**Rother Valley Railway Transport & Works Act Order  
Footpath Diversion S&R 31 (SAL/31/1) Rail Levels**

**Approved Scheme**

**Changes to meet concerns over footpath under Bridge 12**

**Changes to meet Condition 20 Highway England Departures from Standard**

JOB TITLE: ROTHER VALLEY RAILWAY  
"THE CLAPPERS" TO JUNCTION ROAD, ROBERTSBURGH  
CLIENT: ROTHER VALLEY RAILWAY LTD.  
DRAWING TITLE: TITLE PLANS  
SCALE: 1:1250  
DWG. No.: Plan B-2  
DATE: October 2016  
DRAWN BY: R O'Grady  
REV. NO.: B  
JOB No.: 13/08/024  
DATE: October 2016  
REV. NO.: B

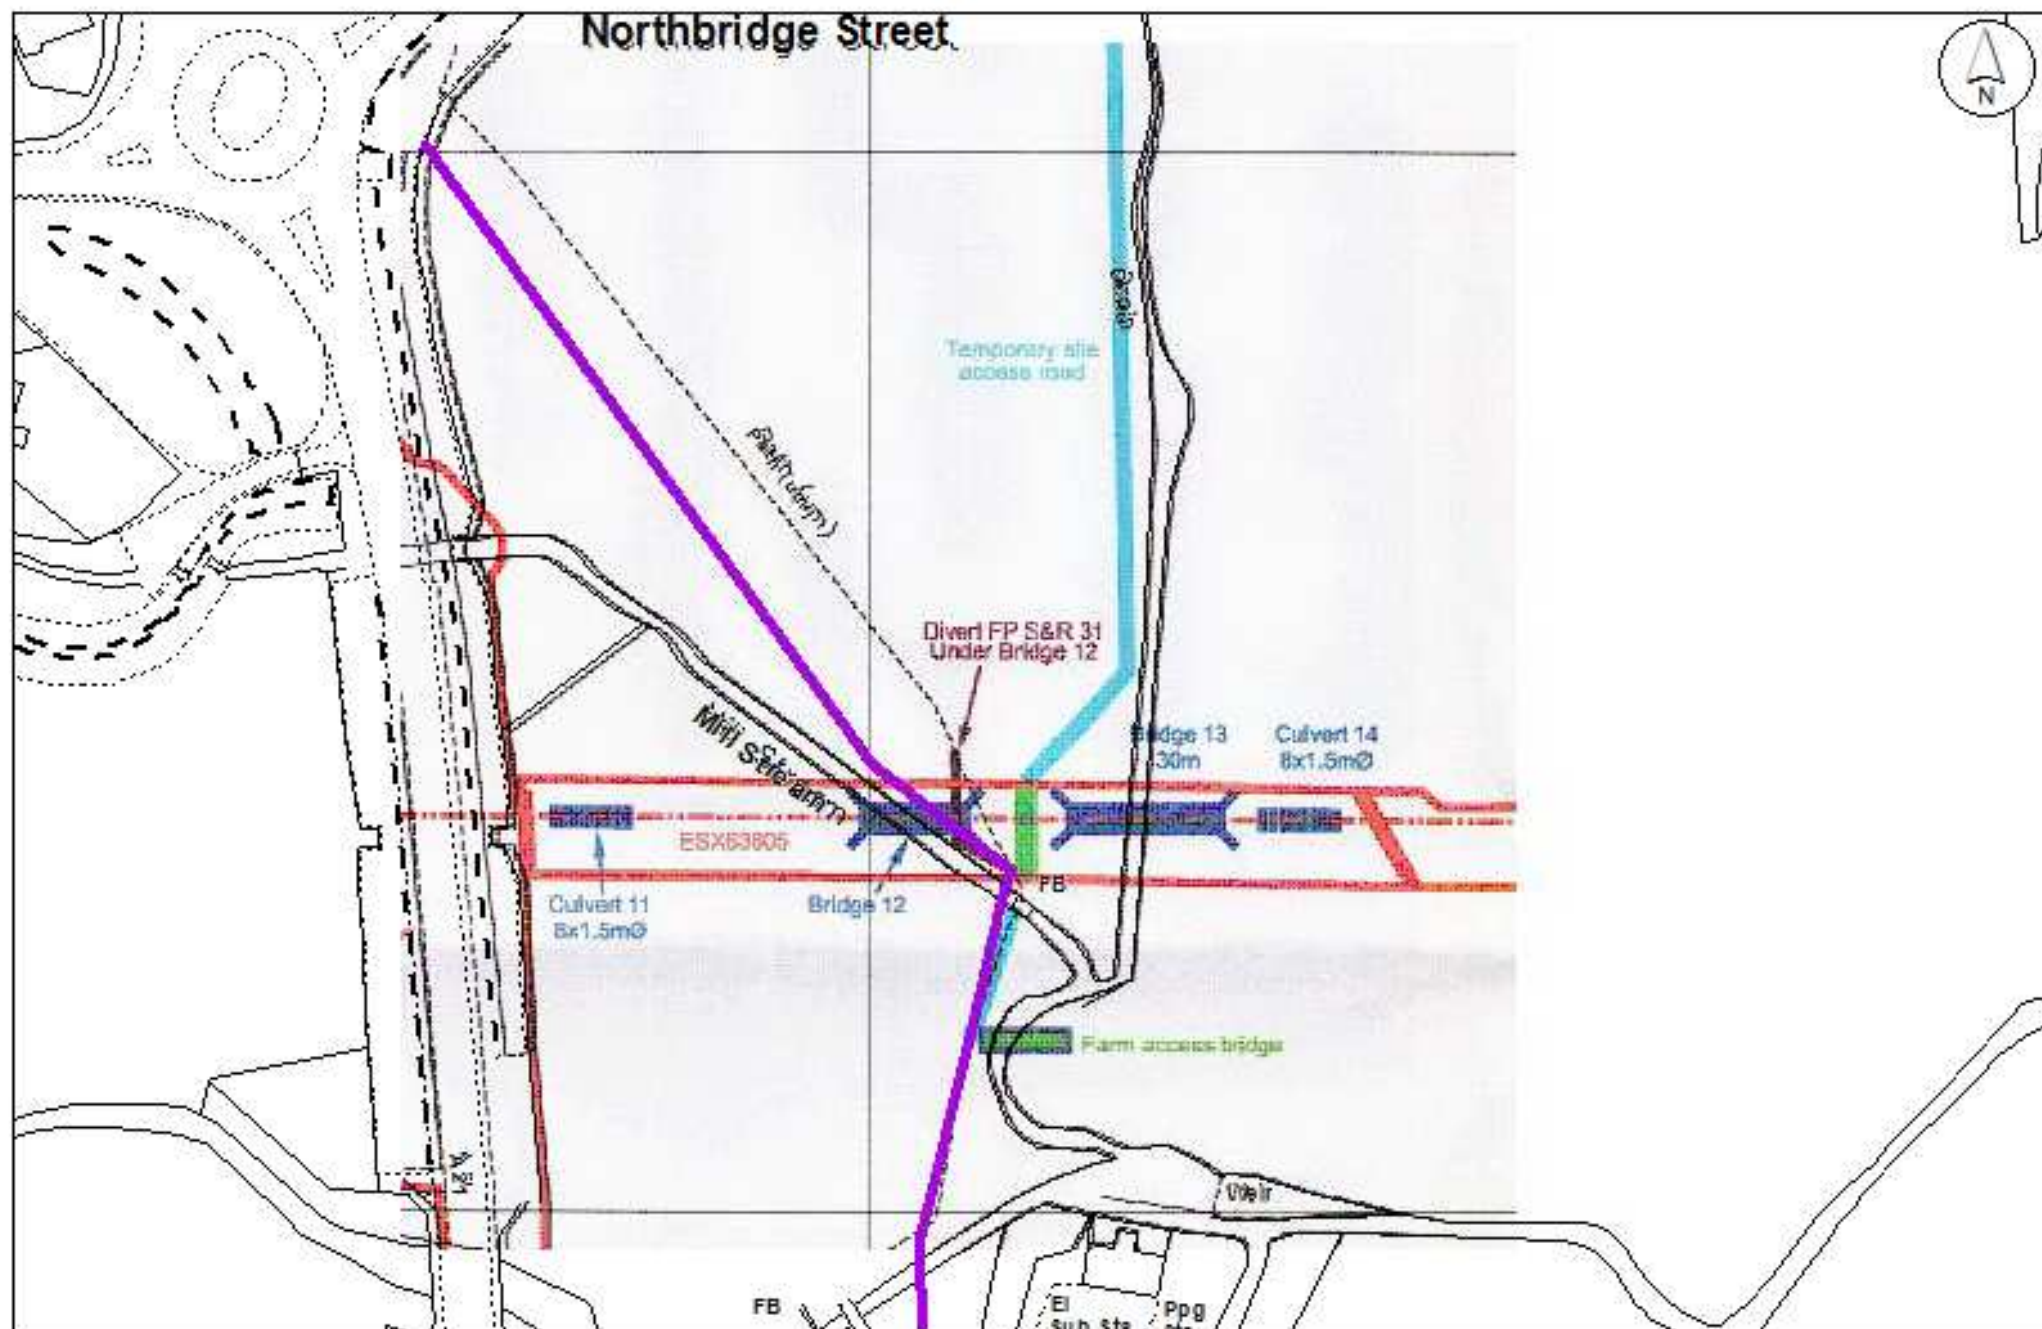
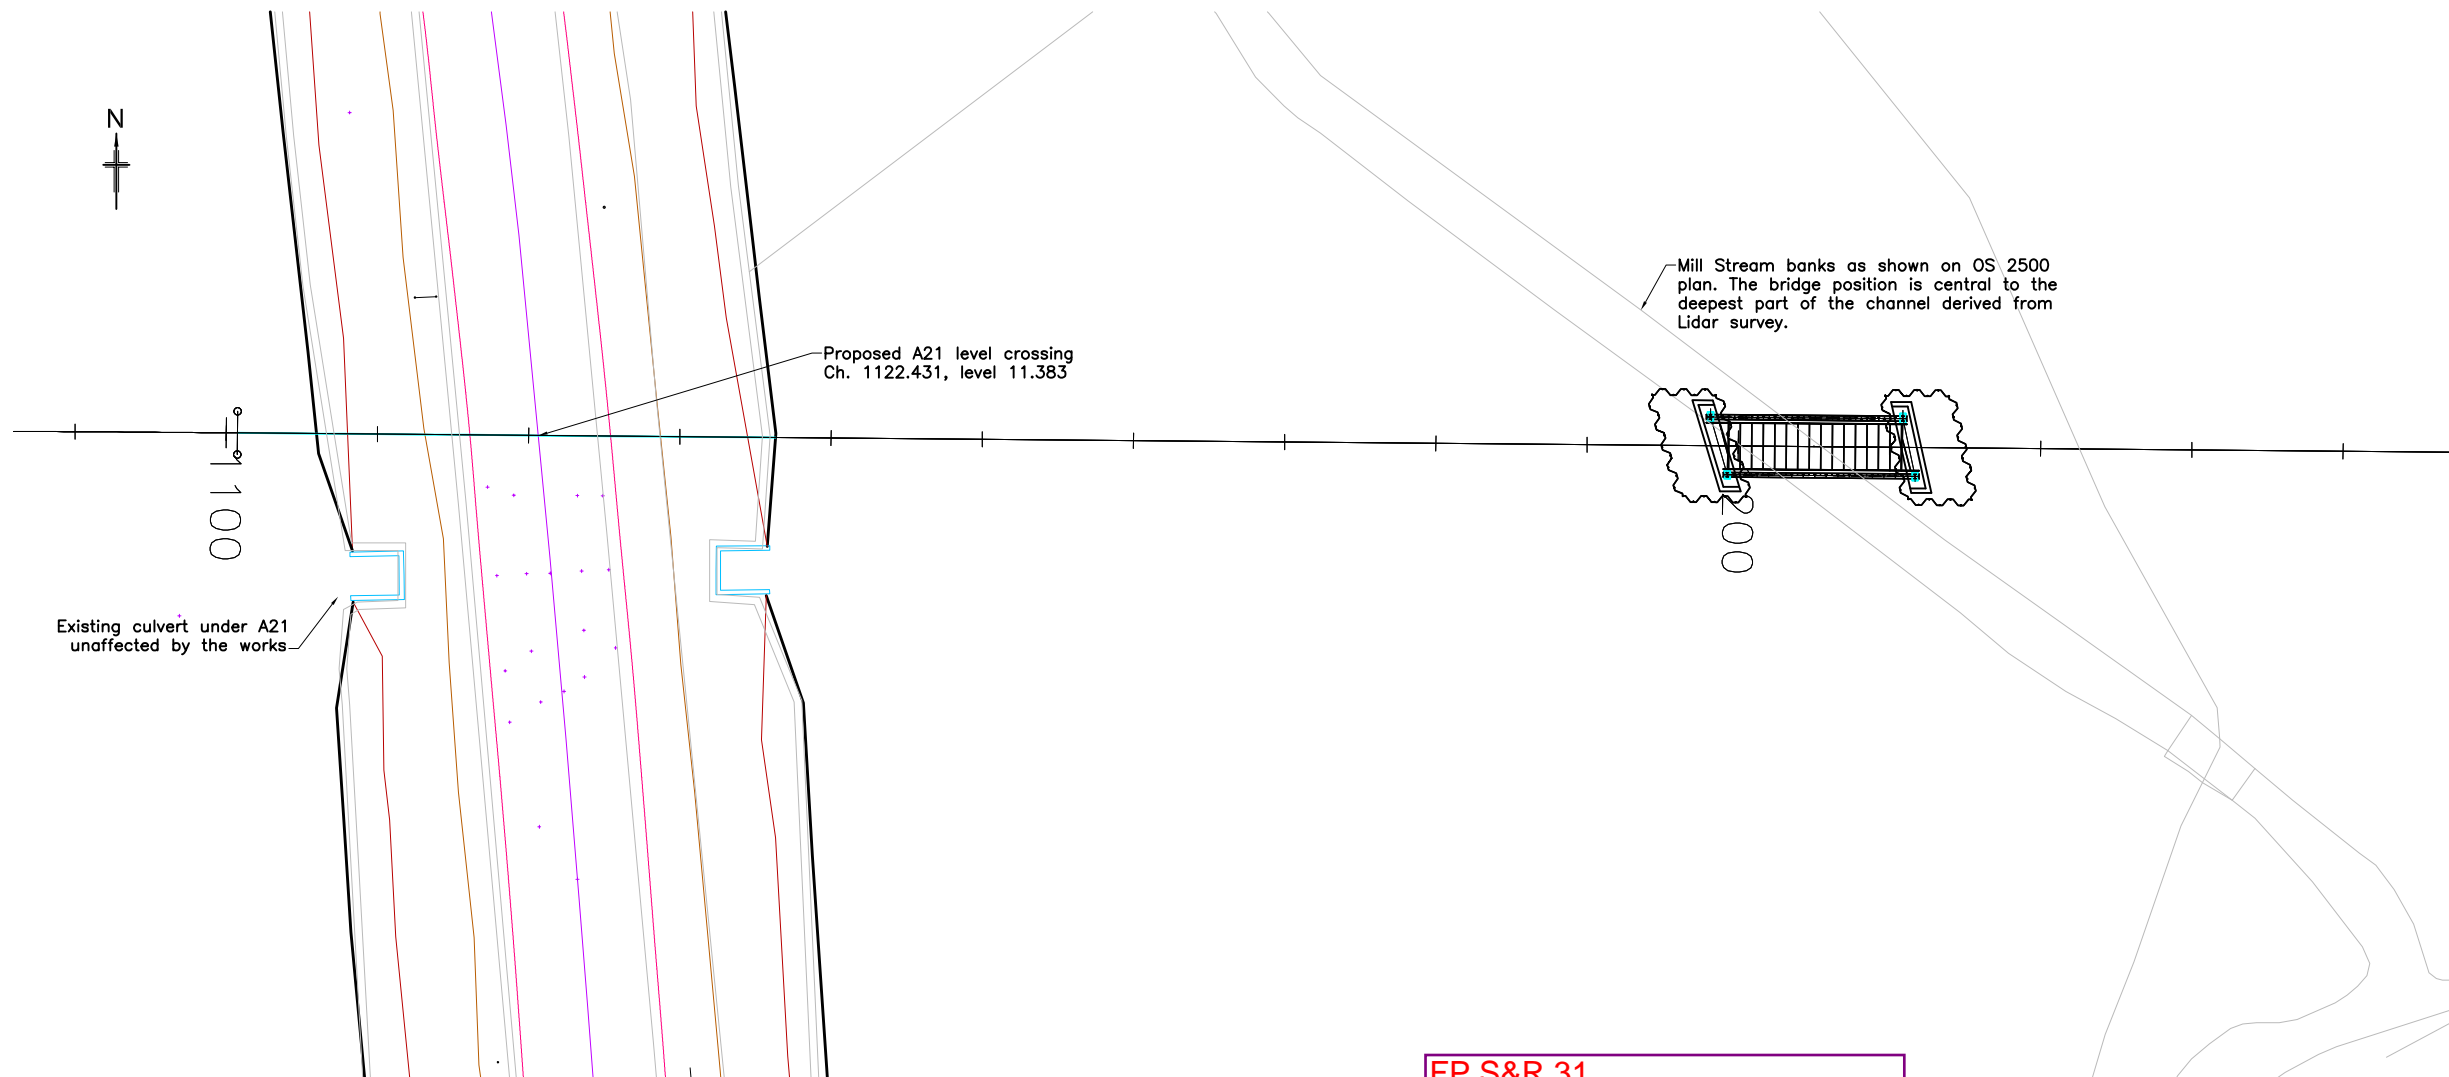
- 3 In its grant of planning permission Rother DC included in Condition 2 a list of approved drawings which. included "Drawing no. Plan B – 2 dated October 2016" (Decision Notice page 1). This plan shows the footpath being diverted under Bridge No 12 (attached at Appendix 1). The plan is approved for the purpose of the principle of the restoration of the railway line and bridge in this location and is subject to approval of detailed design. This will involve ESCC in respect of the highway and the Environment Agency in respect of the watercourse as well as the local planning authority.

It had been assumed that a diversion would be needed, but that may not be necessary. There is a variance between the walked and recorded line of the path. The plan attached ('Footpath 31 (bridge 12)') shows the recorded line overlaid on the application drawing 'B - 2 Rev B Title Plans 3'. The change to the recorded line of the path would effectively be confined to the path being re-angled very slightly where it runs beneath the bridge. This would really not warrant a diversion order in my view.

Drawing No.  
**RVR - UB12 - 001**

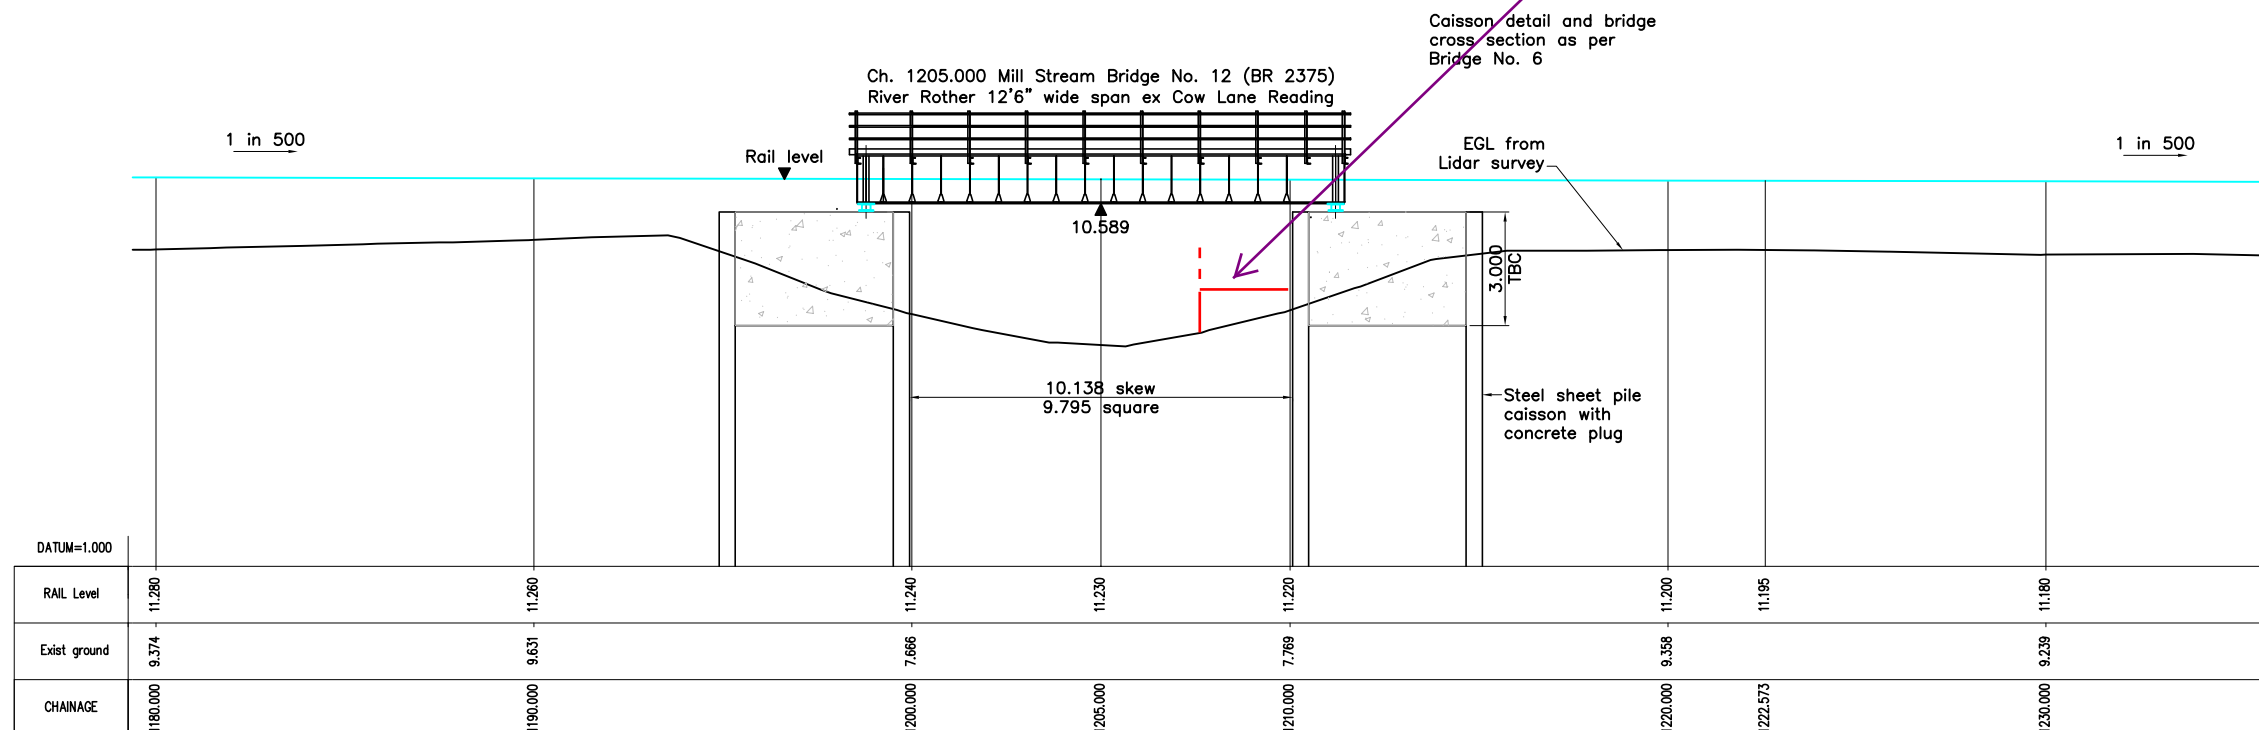
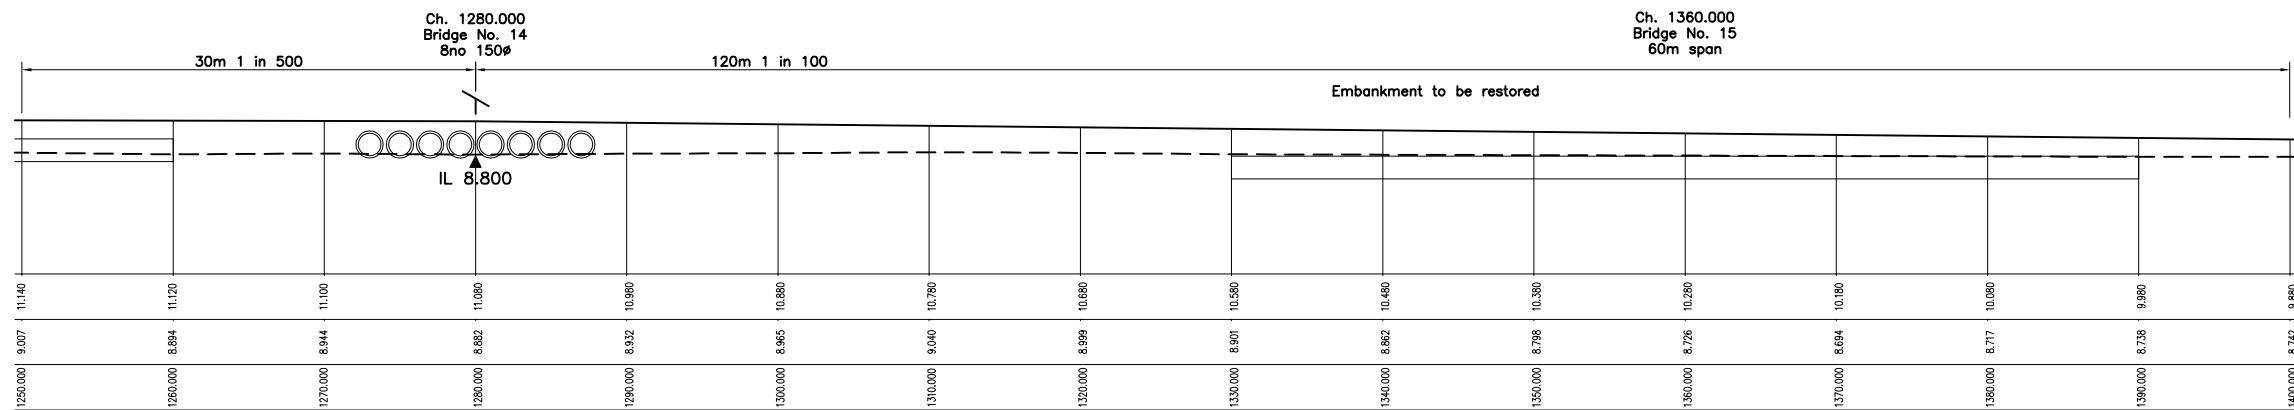
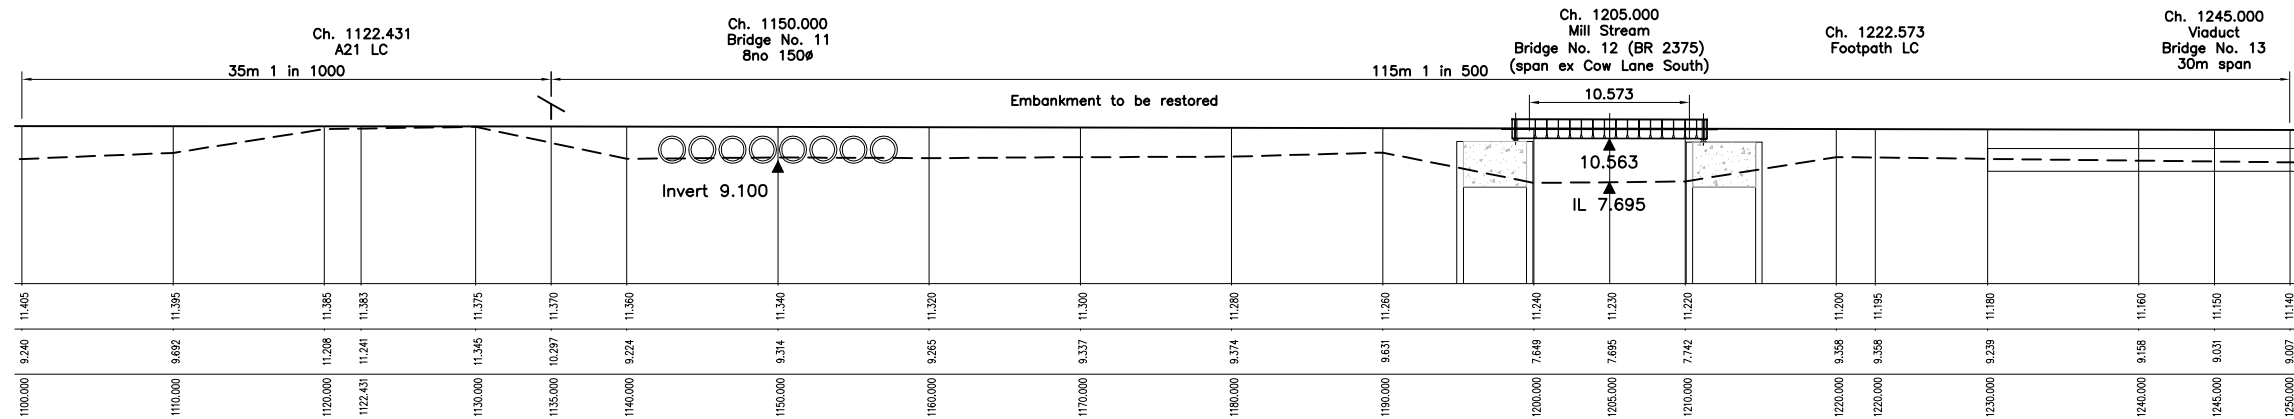
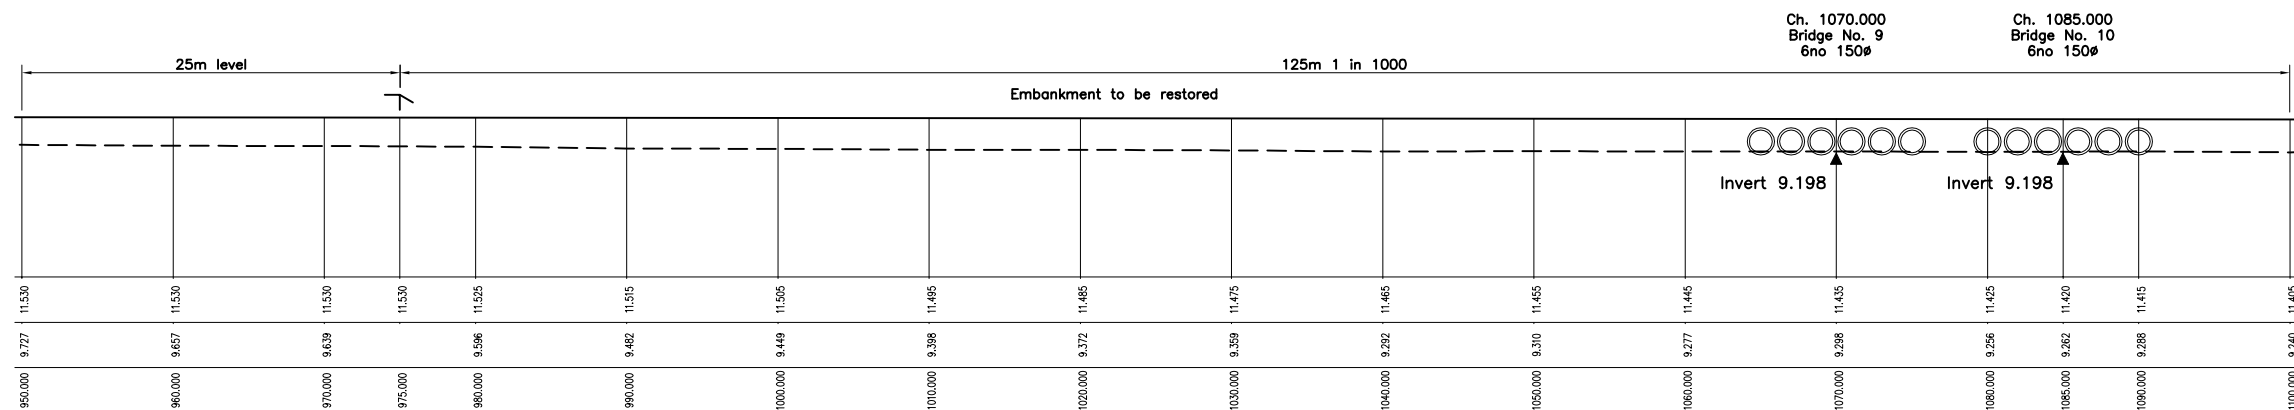
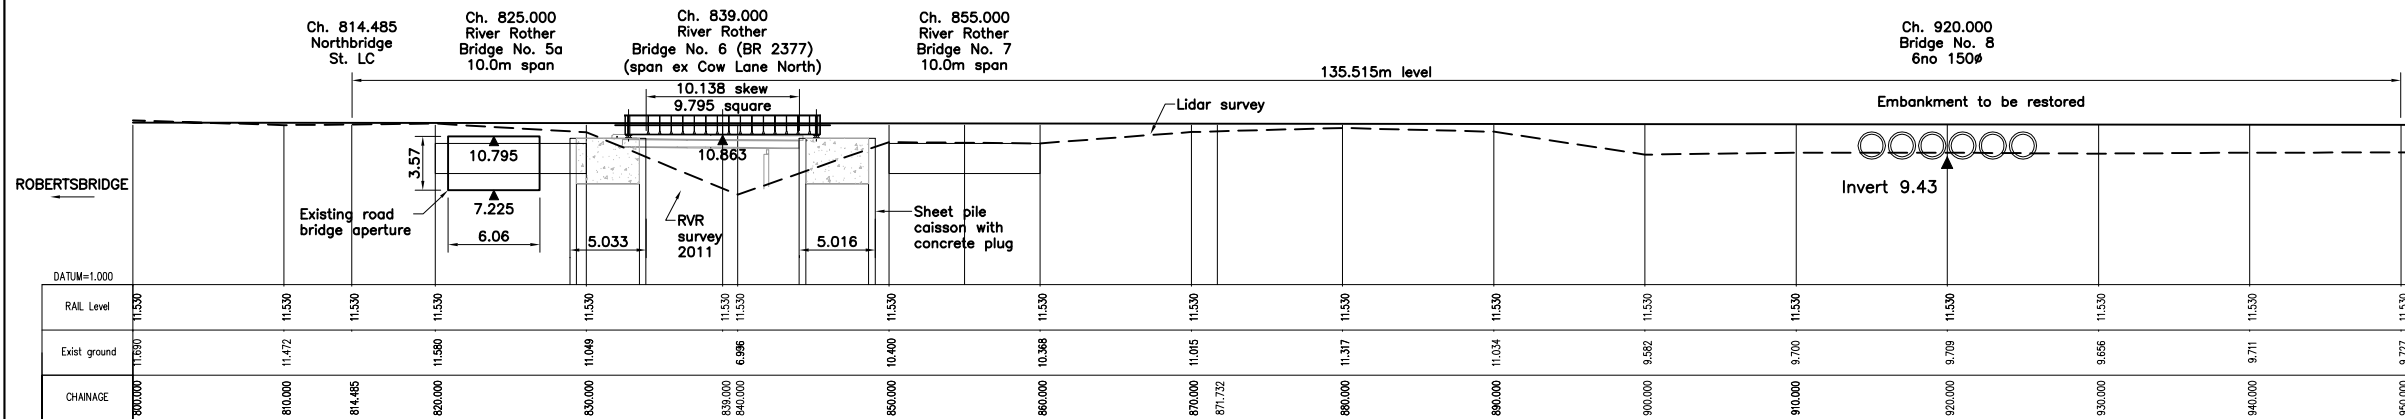
- 6 The set of drawing in Volume II as delivered includes Drawing No RVR – UB12 – 001. (Bridge 12) Titled "MILL STREAM BRIDGE SITE PLAN" and dated 10 October 2013 (attached at Appendix 2). The drawing is annotated with a footpath drawn under the bridge and a comment "FP S&R 31 2.3m x 2.3m per DMRB Vol 6 Sec 3 Pt 1 - TD 36/93" on the Elevation.
